**18th December 2020****Notification of Change**

All BIM2005 enclosures

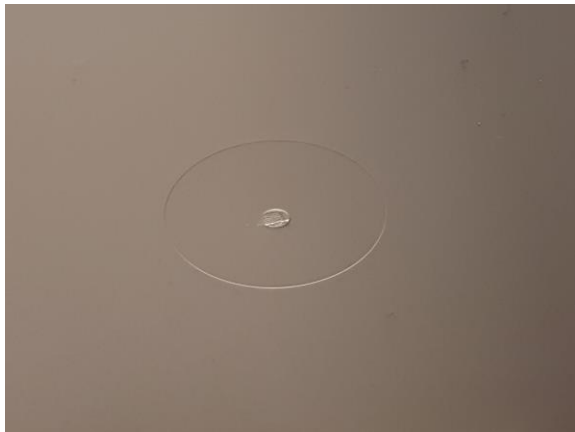
The injection mould tool for the BIM2005 enclosure will now have a bush placed around the injection point which will leave a witness as shown below. This is a cosmetic change on underside of the enclosure base to aid with flow rates. It does not affect the fit, form or function of enclosure.
